***Nanticoke T.S. - Breaker Replacement Program
Notification of Approval of Connection Proposal
CAA ID Number: 2004-EX196***

Nanticoke T.S. Breaker Replacement Program (CAA ID Number: 2004-EX196)

ASSESSMENT SUMMARY

Figure 1: Single Line Diagram – Nanticoke T.S.

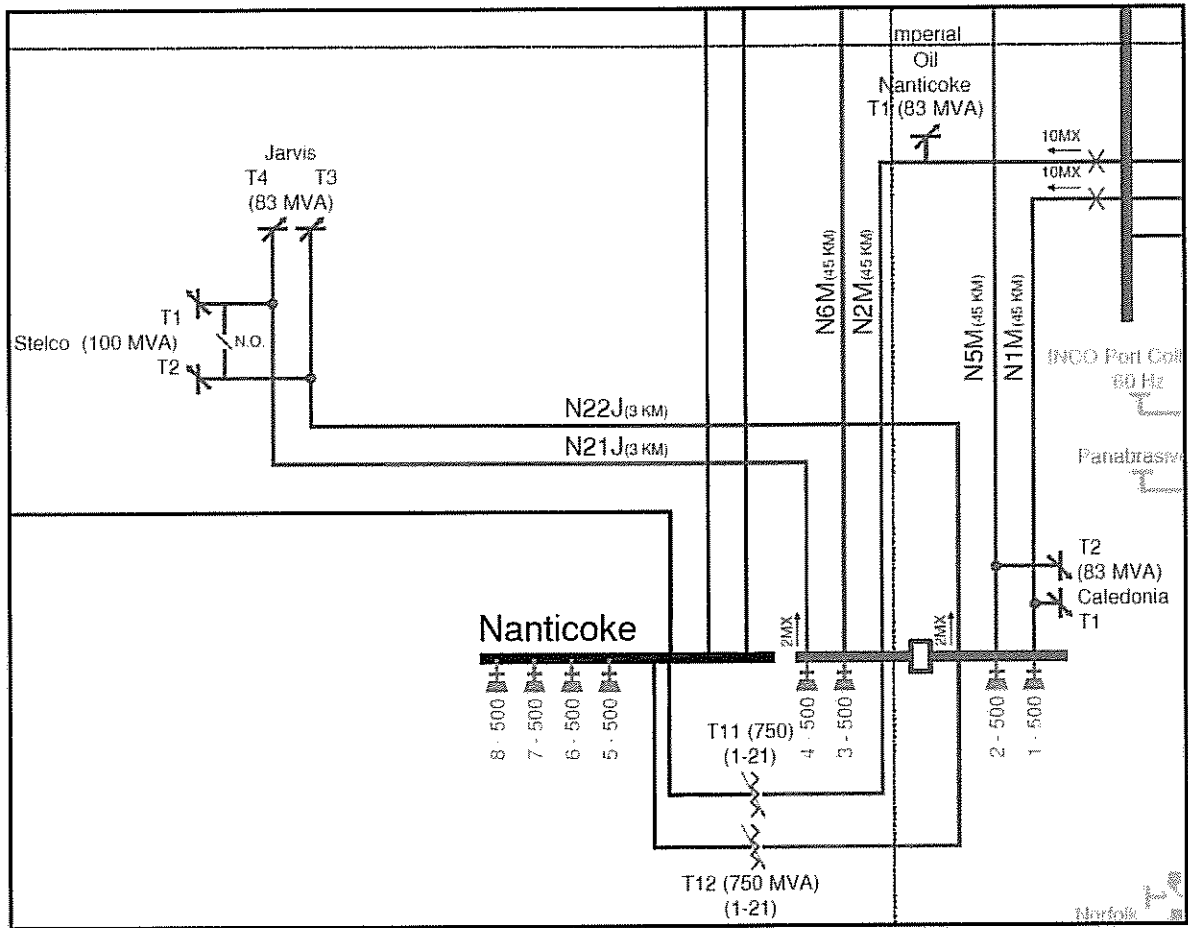
During 2006 Hydro One proposes to replace a number of 230 kV air blast circuit breakers that have reached the end of their useful life at Nanticoke T.S. Section 2.0 contains a table showing the identifiers of the breakers that are being replaced, as well as the ratings of the new units. Figure 1 shows these breakers in the single line diagram.

The assessment indicates that the ratings of the new breakers are either higher or at least the same as the existing breakers and that the interrupting capability of the new breakers is adequate for the short circuit levels experienced in the current system.

The Transmission System Code (Appendix 2) recommends that all 230 kV breakers have an interrupting capability of 63 kA. The new 230 kV SF6 breakers at Nanticoke T.S. are rated at the performance standard set in the TSC. The 2003 Short Circuit Survey prepared by Hydro One indicates that the current maximum short circuit levels at Nanticoke T.S. are around 46.9 kA and the system in that area has not suffered major modifications in the last years, it can be concluded that the interrupting capability of the new breakers is adequate. The TSC also recommends that 230 kV breakers have an interrupting time of less than 3 cycles. As indicated in the table above, the breakers have an interrupting time of 2 cycles or less, thus meeting the TSC requirement. Although the new breakers are slightly slower than the exiting breakers, the overall increase in fault interruption time (by about 12 ms) is not considered to affect adversely the reliability of the system.

In addition to operating continuously at 250 kV the new breakers must be capable of remaining closed (no automatic tripping) during the re-preparation period (30 minutes or less) following recognized contingencies when system voltages are above 250 kV, but are not required to interrupt fault currents when system voltages are above 250 kV.
